DRAWN	A. LEGGATE	FLUOROSILICONE RUBBER DOOR SEAL	CVR 170
CHECKED	H. VAFI		
STRESSED	J. HORNSTEIN		SHEET: 1 OF 1
APPROVED	A. LEGGATE

REV: B - 25 OCT 2010

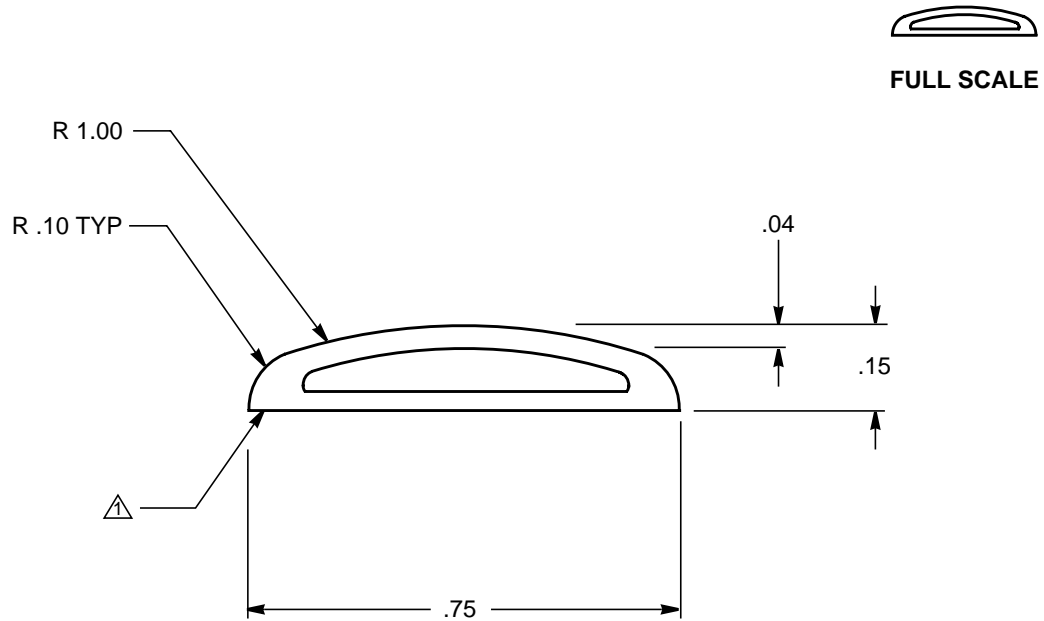
REDRAWN STANDARD AT ISSUE "B" WITH EDITORIAL CHANGES
(B) MATERIAL SPECIFICATION REVISED, "MIL-R-25988, TYPE II, CLASS I, GRADE 40" WAS "(CW9712*)"
NOTE " * CHASE - WALTON COMPOUND" REMOVED

- (B) FLUOROSILICONE RUBBER PER MIL-R-25988, TYPE II, CLASS I, GRADE 40 COVERED WITH BIAS CUT SQUARE WEAVE DACRON FABRIC.
THE FABRIC SHALL HAVE A "RUBBER FREE OUTSIDE SURFACE AND SHALL BE BONDED TO THE FLUOROSILICONE.
